**CID-23-06  
Parker Ridge  
Construction Infrastructure Plans  
2nd Submittal  
Planning/ZONING Comments**

The following is the Second Submittal review for the Construction Infrastructure Drawings for Parker Ridge, completed by BGE for Lennar Carolinas LLC., dated June 1, 2023 and revised August 1, 2023. The project proposes the construction of 161 single-family detached dwellings and 114 townhouse dwellings, on approximately 87 acres, located on School Street and Redford Place Drive. The subject site was Rezoned under case number MA22-03 to RM-CZ, Cluster option and RH-CZ. As part of the rezoning, a number of conditions were attached to the approval.

***Site Plan Sheet(s)***

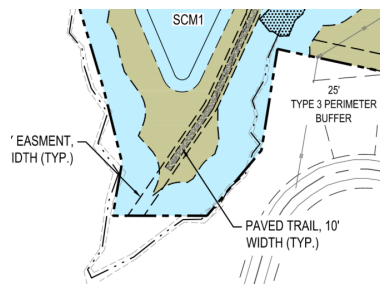
3. **Repeat Comment:** The parking calculations show that six (6) parking spaces for the Future Amenity/Clubhouse will be located near Open Space #6. Staff recommends that the spaces be intended for Clubhouse Use only, and signed appropriately. Add a standard detail of the sign to the detail sheets within this plan.
